**Petition: PZ 21-018**

**Application: Rezoning**

**Petition:** To modify the conditions of zoning to allow a 20' driveway easement through the 20' undisturbed buffer (or landscaped buffer) and no access easement to allow driveway access to the property on Shipp Road (2780 Lost Lakes Drive – aka Lot 128 of Lost Mountain Lakes Subdv).

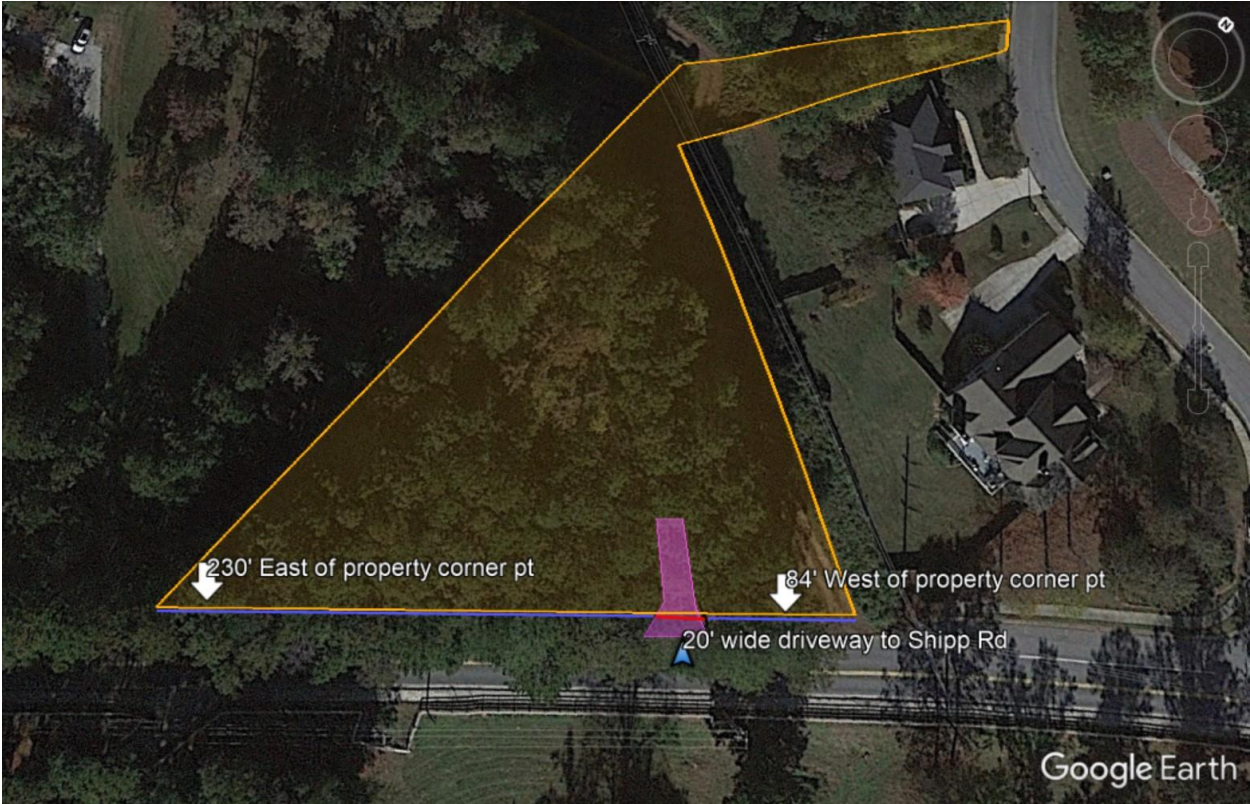
3. Applicants propose the 20' driveway would be ~84' west of the SE property corner point, and ~230' east of the SW corner point of the property.
4. Applicants agree and intend to comply with front landscape strip requirements and entry landscaping with Lost Mountain Lakes subdivision.

The proposed 20' driveway would be ~84' west of the SE property corner point, and ~230' east of the SW corner point of the property. See below.

### **Preliminary Sight Distance Profile and Sight Distance Triangle Review:**

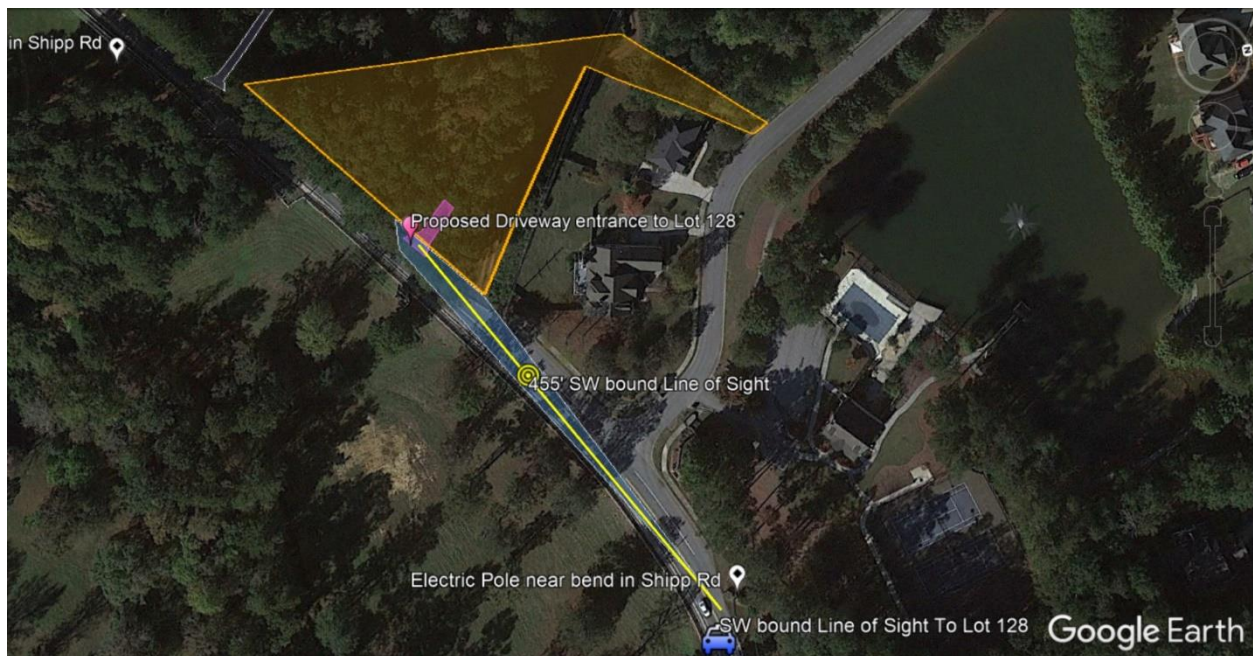
However, with Google earth and Streetview tools, we can show with reasonable confidence that the line of sight along Shipp Rd towards the property's proposed driveway is 400'+ feet in both directions.

Shipp Rd has less than a 10' incline at the SW direction from the lot as can be seen in the SW bound view. From the crest of the road SW from the proposed driveway NE bound traffic would have 400' of viewable distance. At the posted speed limit of 35 MPH, which converts to 51.33' per second, would be 7.79 seconds of opportunity for reaction from the top of road's crest to the driveway intersection. In addition, the neighboring driveway to the property at 4748 Shipp Rd intersects Shipp Rd even closer to the crest SW of the Shipp Rd, which does not appear to affect the safety of the area.

Traveling SW bound, there is 455' of line of sight from the W-SW bend in Shipp Rd. This is 8.86 seconds of reaction time from the SW traffic.

No safety concerns can be seen from this long straight mostly flat stretch of Shipp Rd.
